THE GARDENS AT NORTH CAREFREE CONSTRUCTION DRAWINGS EL PASO COUNTY, STATE OF COLORADO

| GARDENS AT NORTH CAREFREE TITLE SHEET | |

| GARDENS AT NORTH CAREFREE SITE PLAN | |

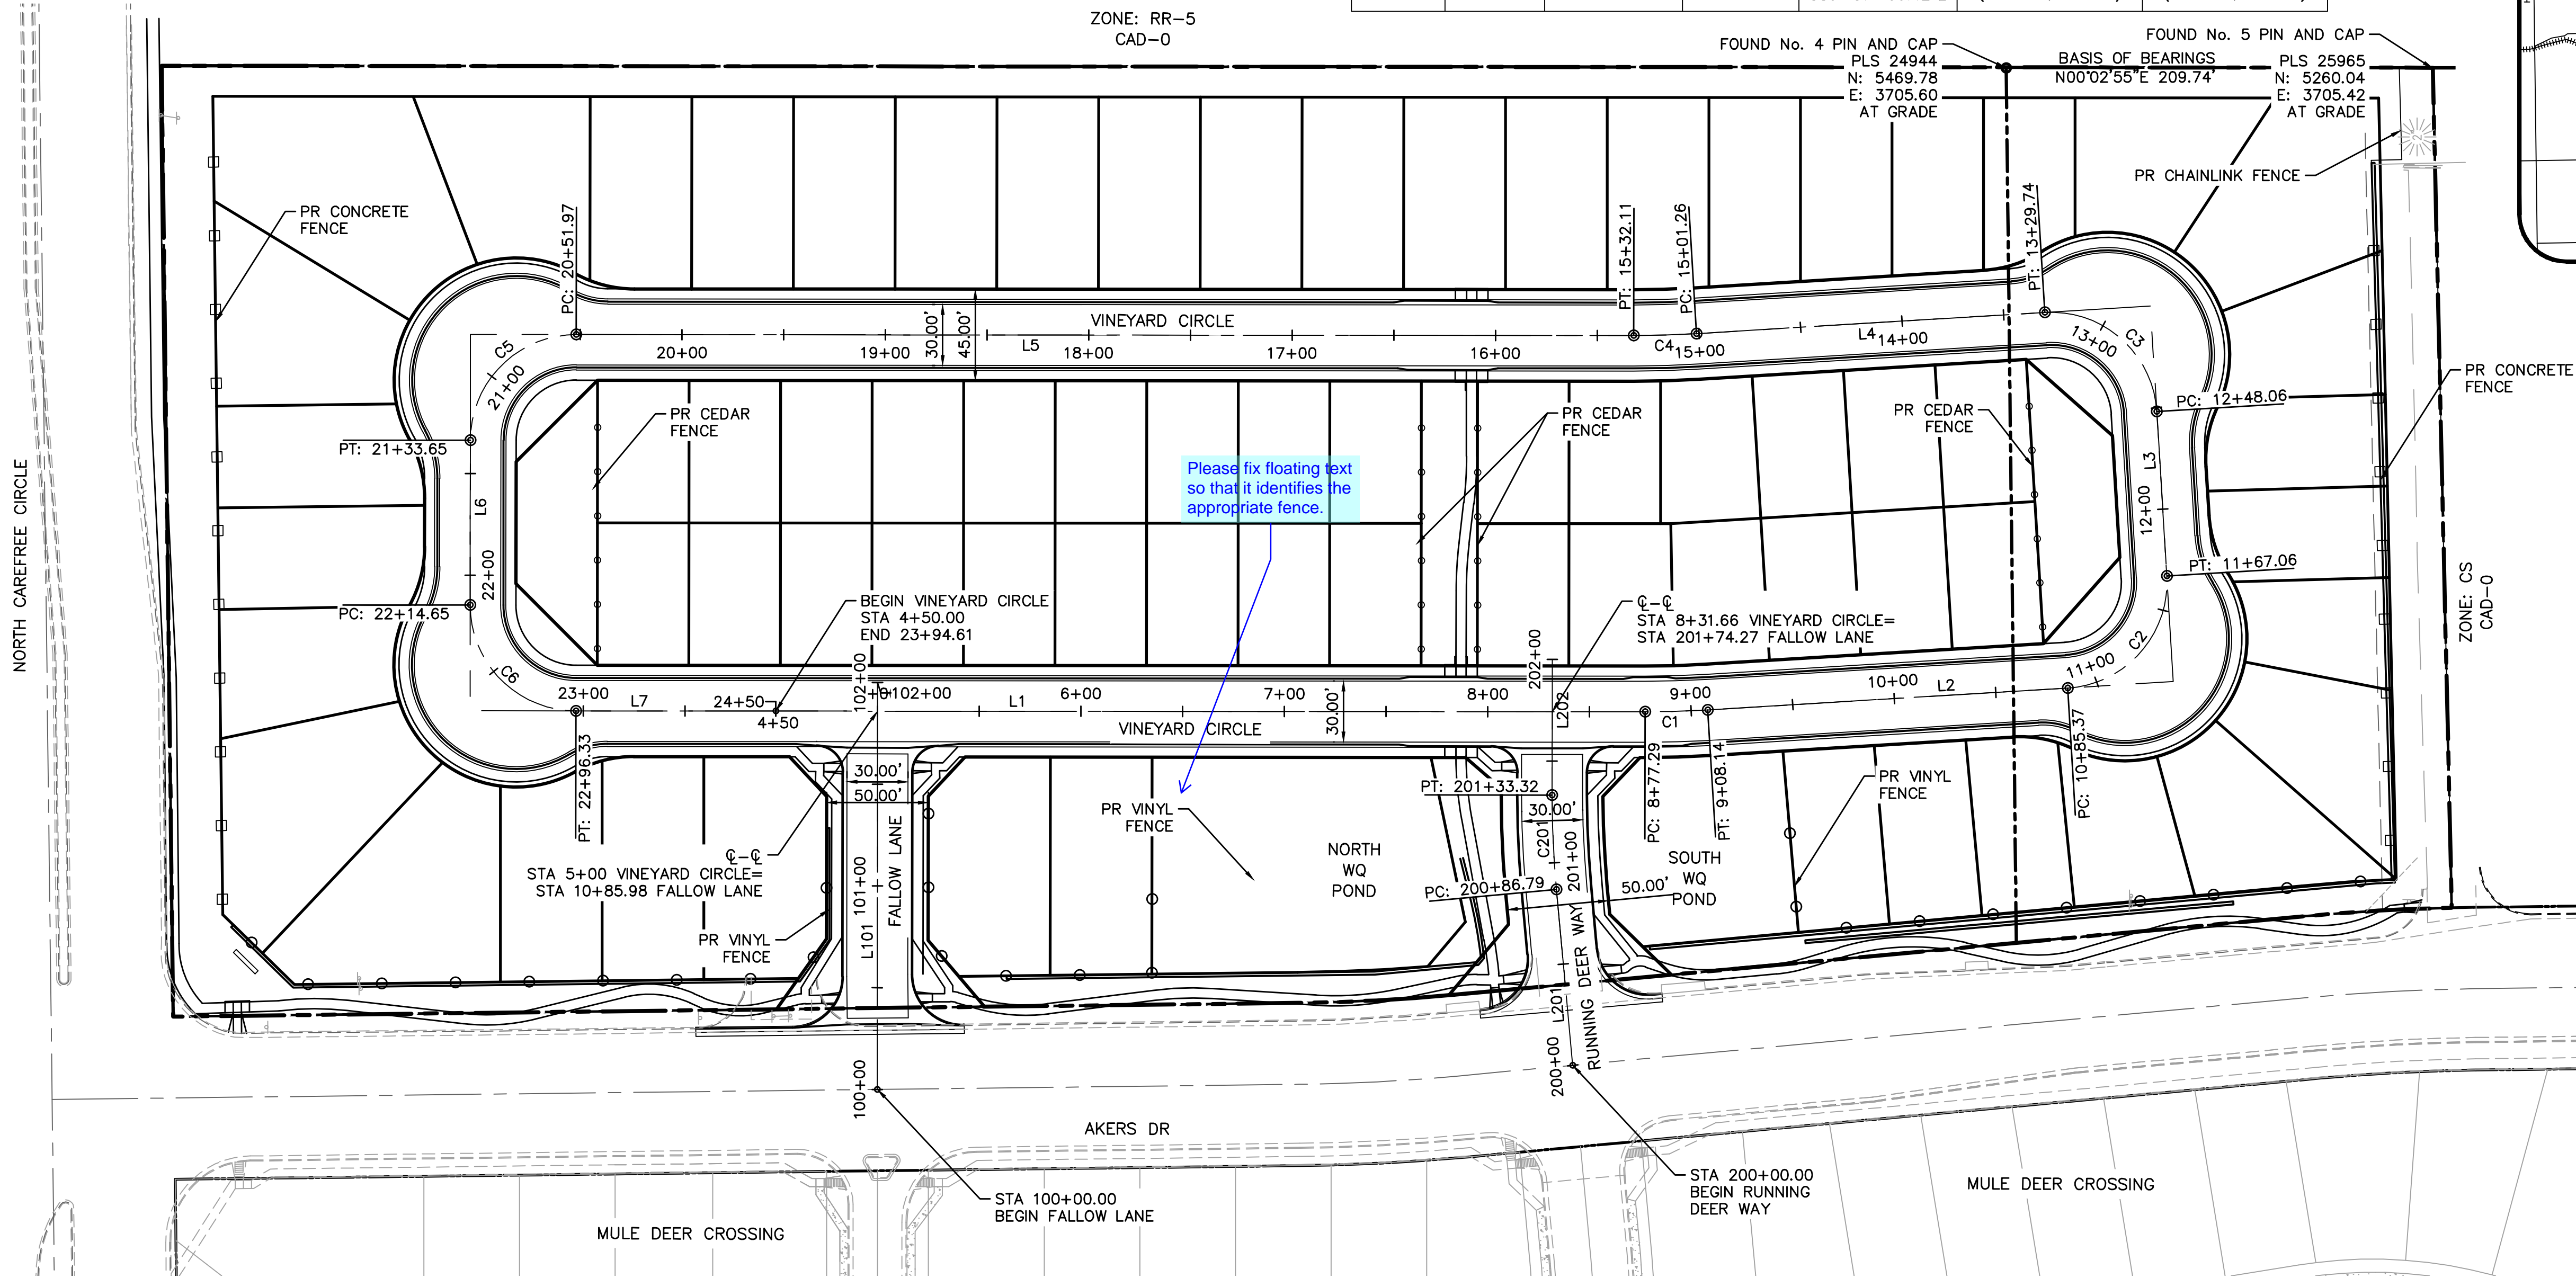
Please fix floating text so that it identifies the appropriate fence.

| THE GARDENS AT NORTH CAREFREE PLAN AND PROFILE VINEYARD CIRCLE | |

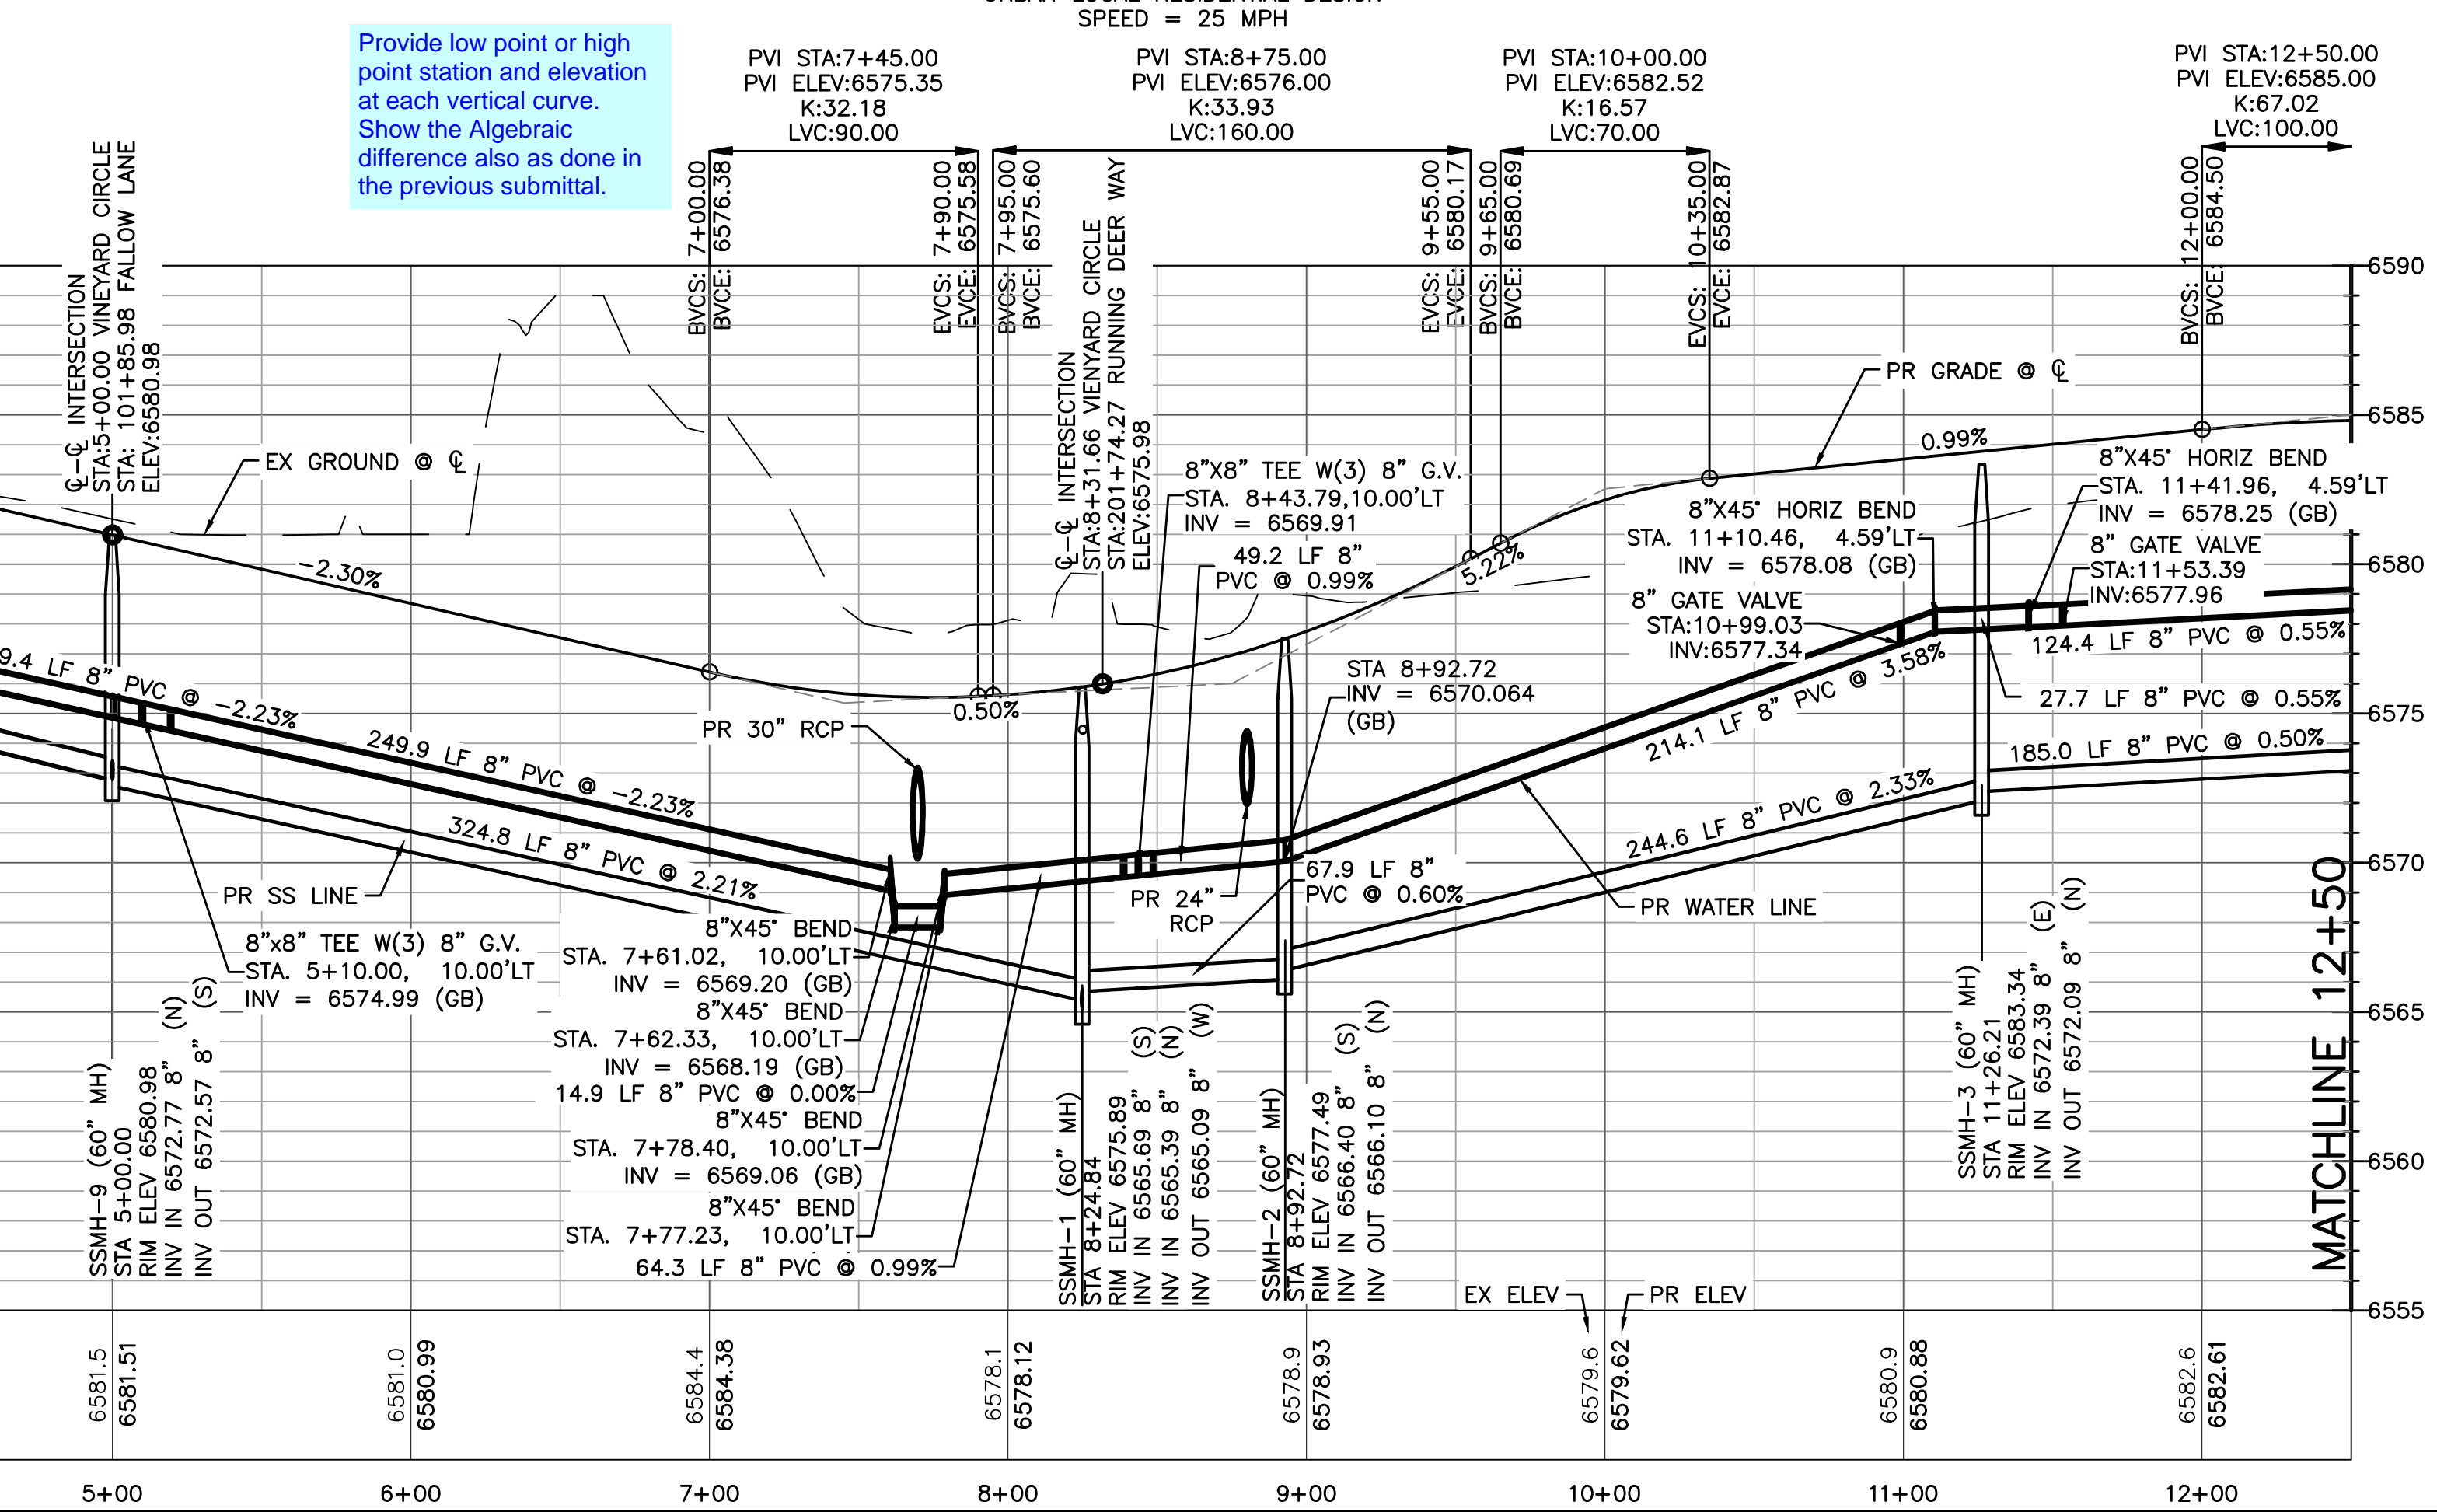
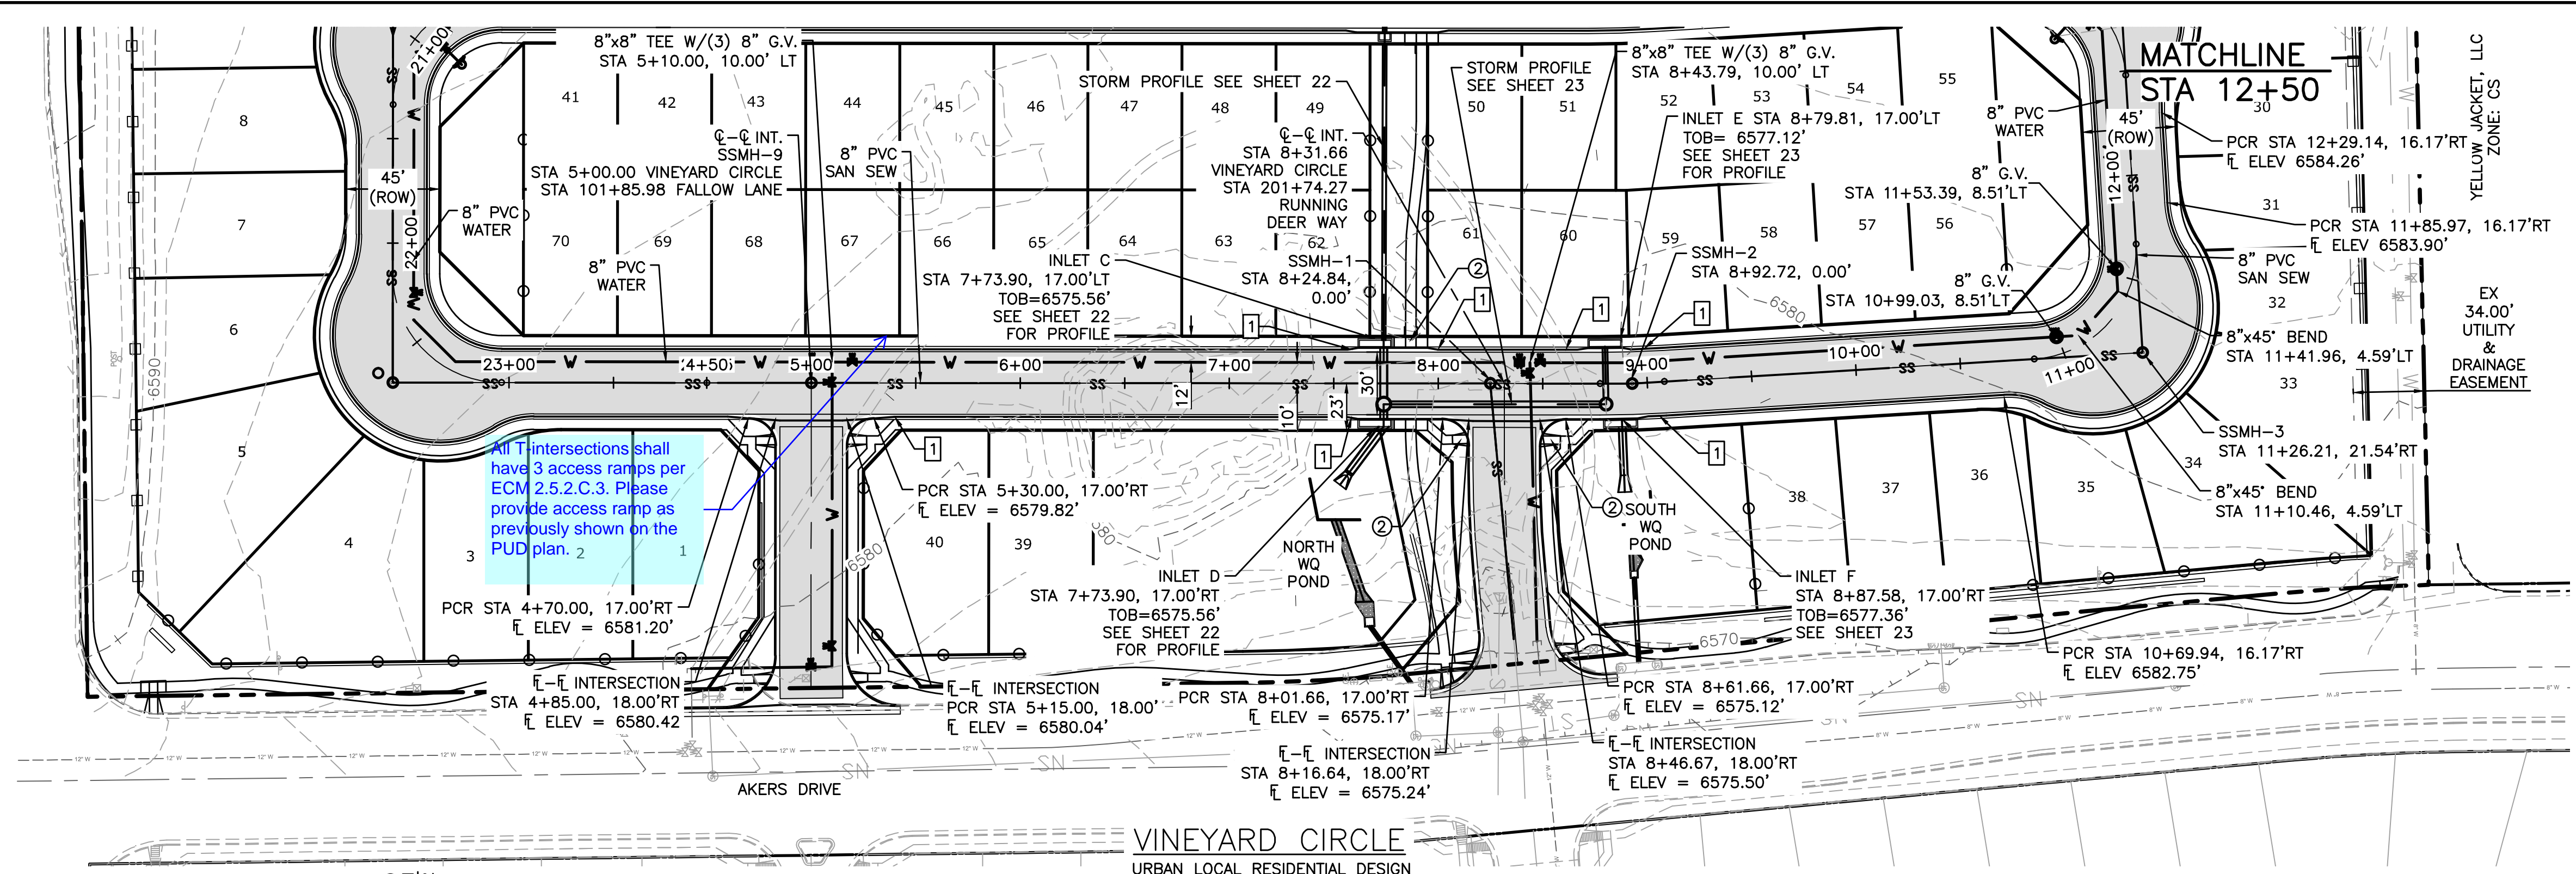
Provide low point or high point station and elevation at each vertical curve. Show the Algebraic difference also as done in the previous submittal.
